HAY CREEK VALLEY
MDDP / ~~FINAL~~ DRAINAGE REPORT

Preliminary Drainage
Report

January 2023

Please update to
PCD File SP-23-01

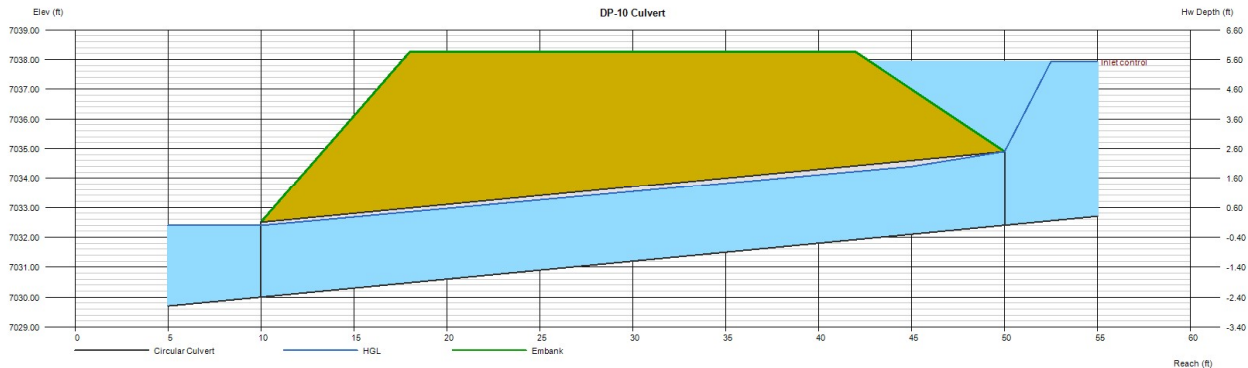
Update culvert design to maintain an Hw/D of 1.5 or less.

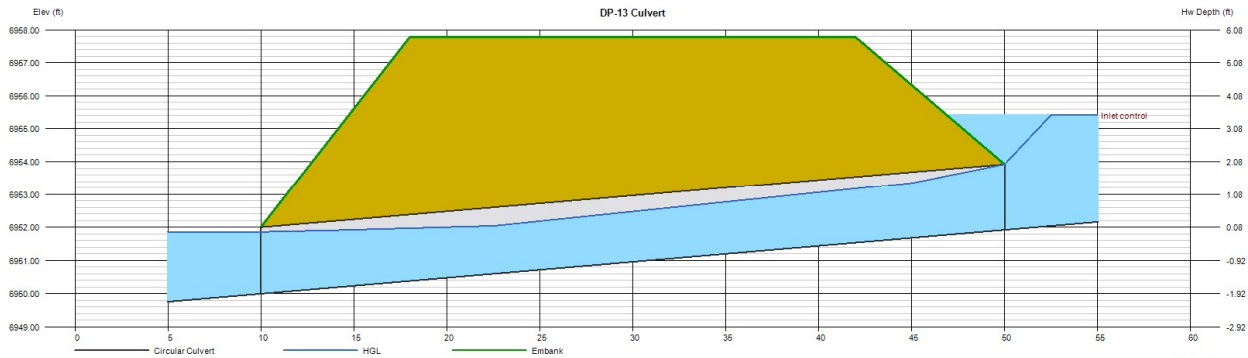
Update culvert design to maintain an Hw/D of 1.5 or less.

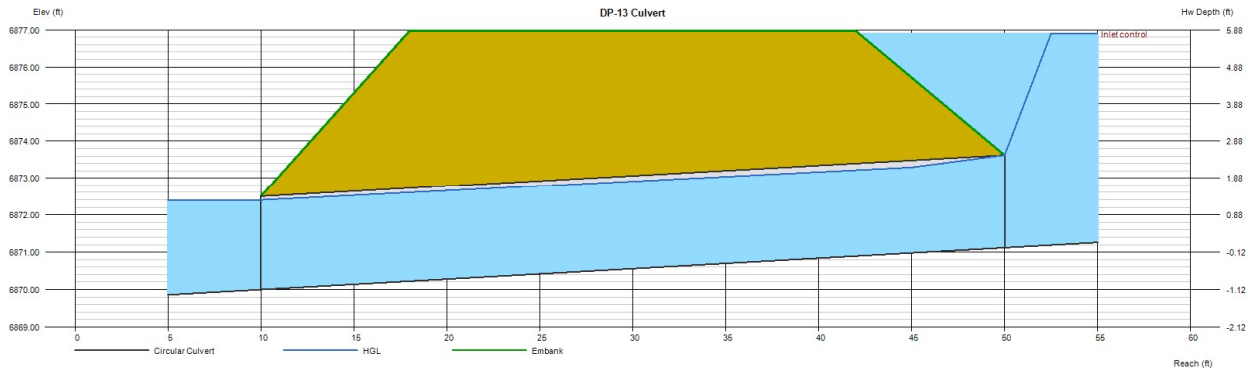
Update culvert design to maintain an Hw/D of 1.5 or less.

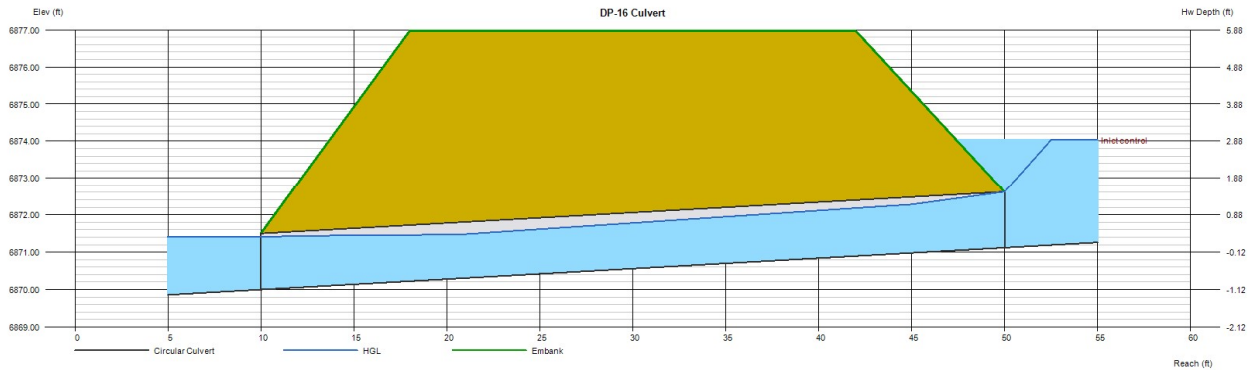
Update culvert design to maintain an Hw/D of 1.5 or less.

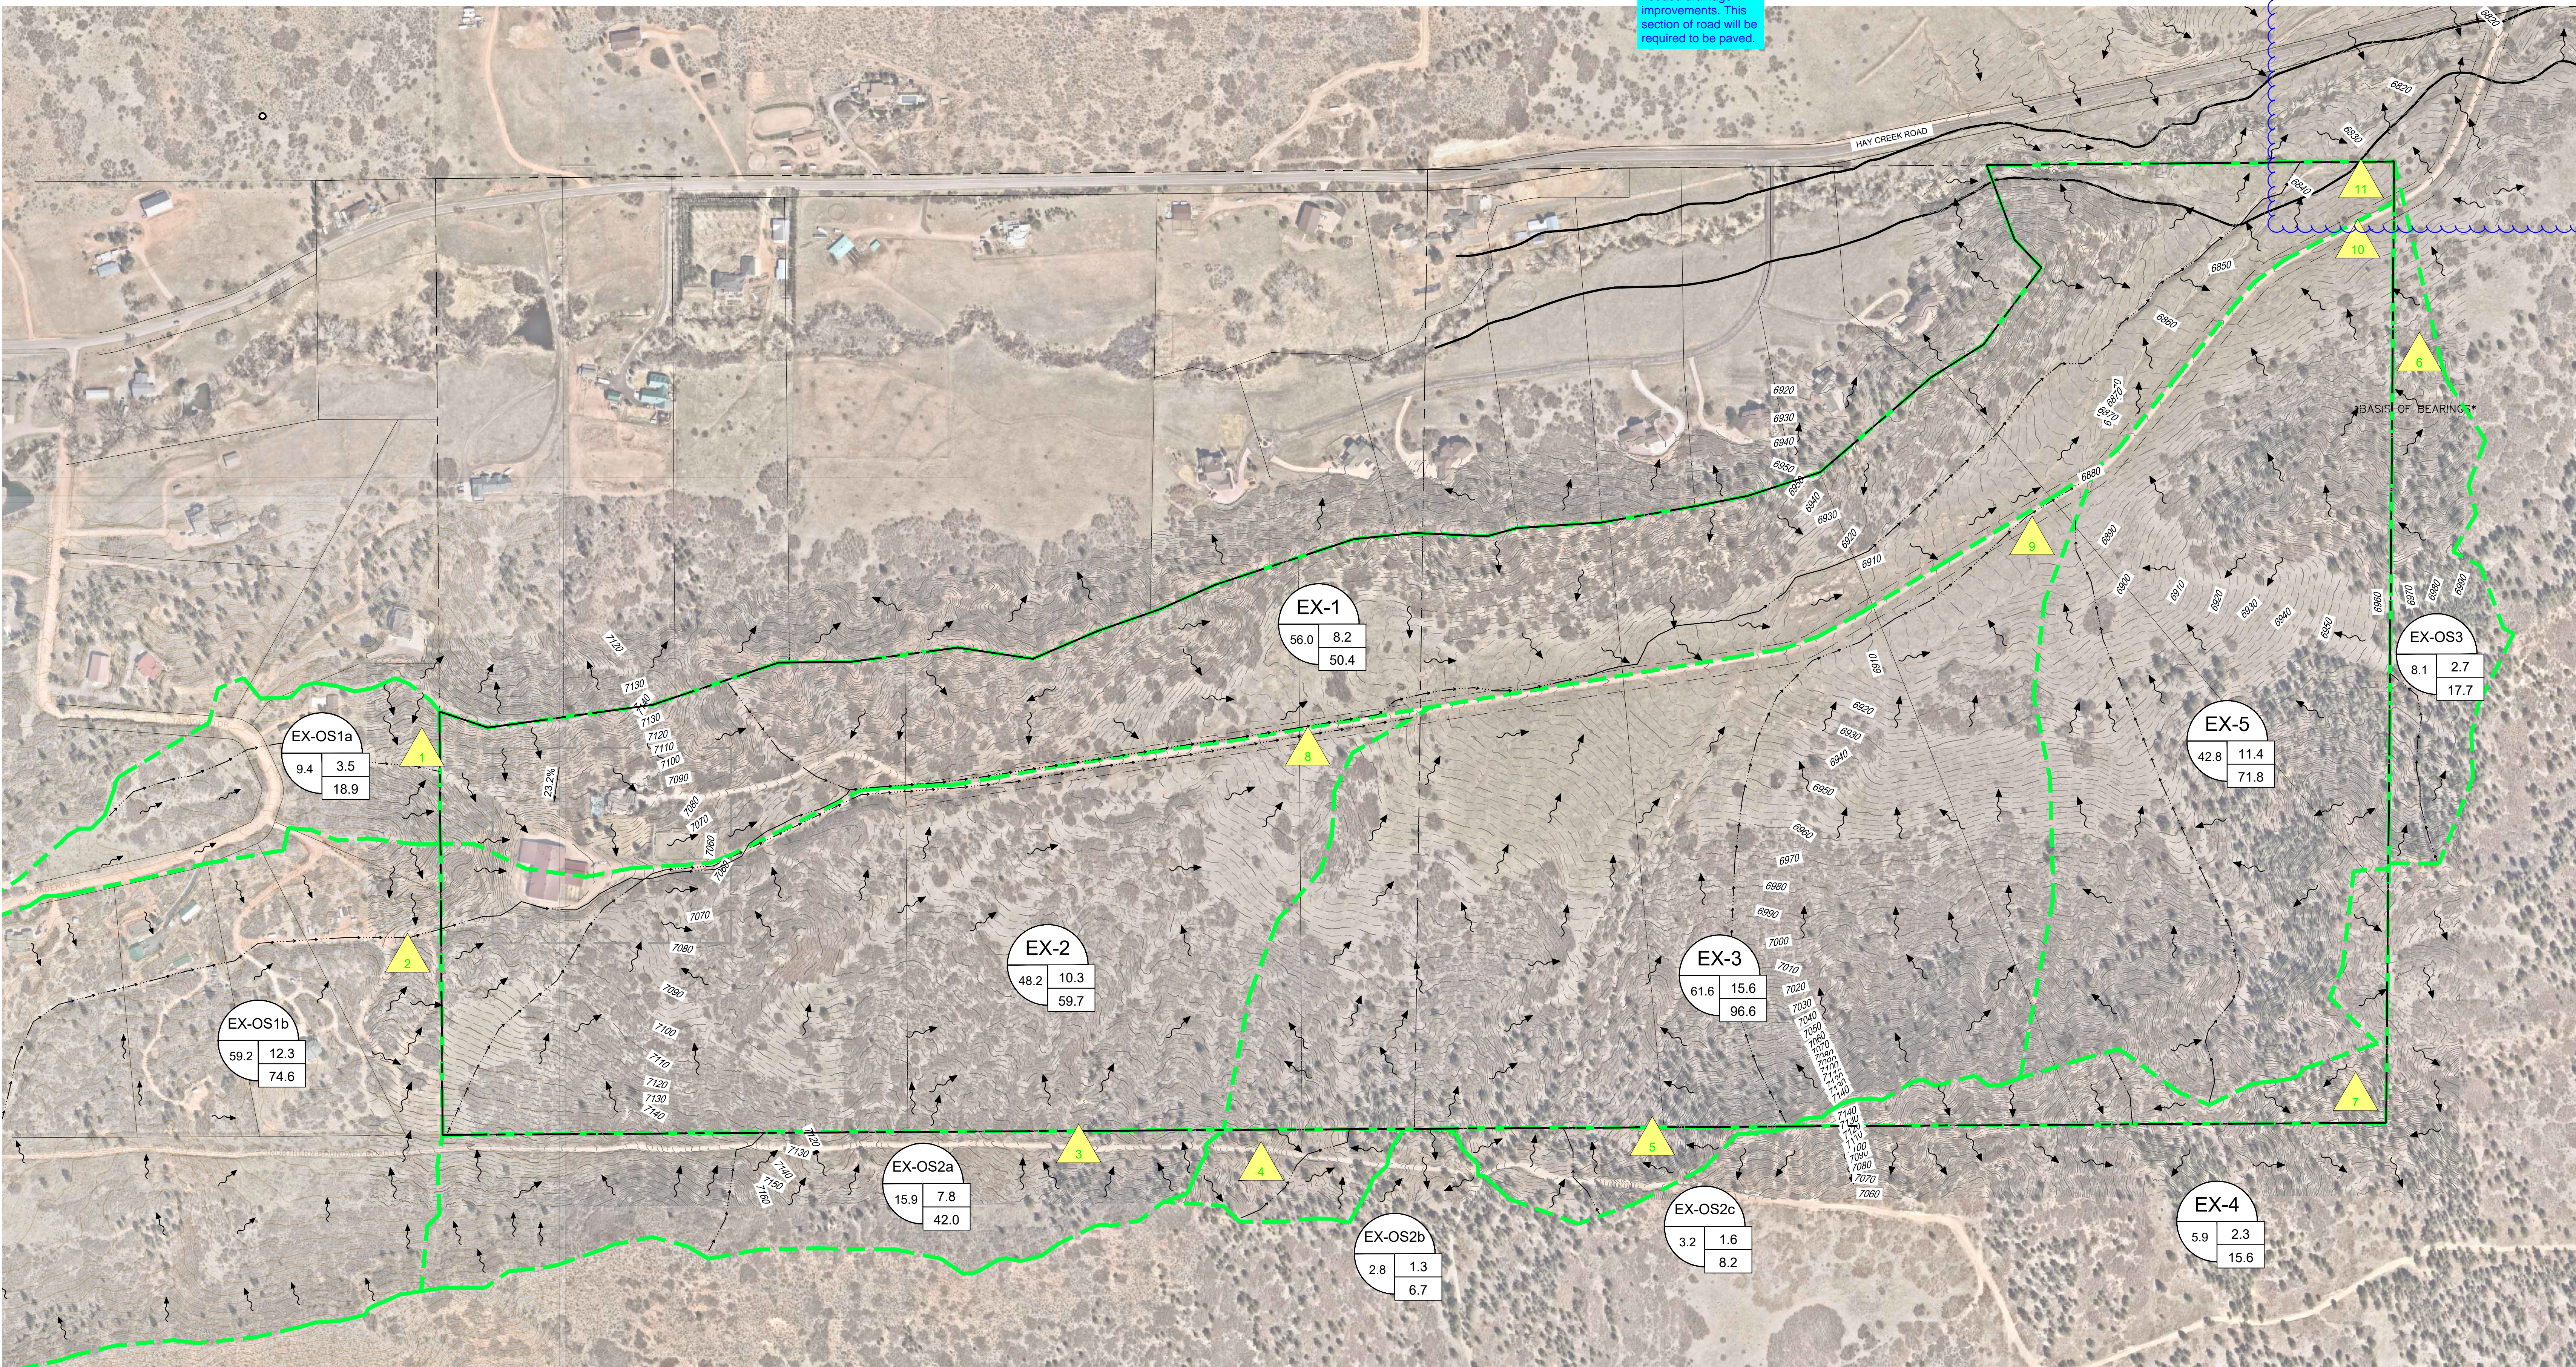
Address this road section to include existing road side ditch condition and needed drainage improvements. This section of road will be required to be paved.
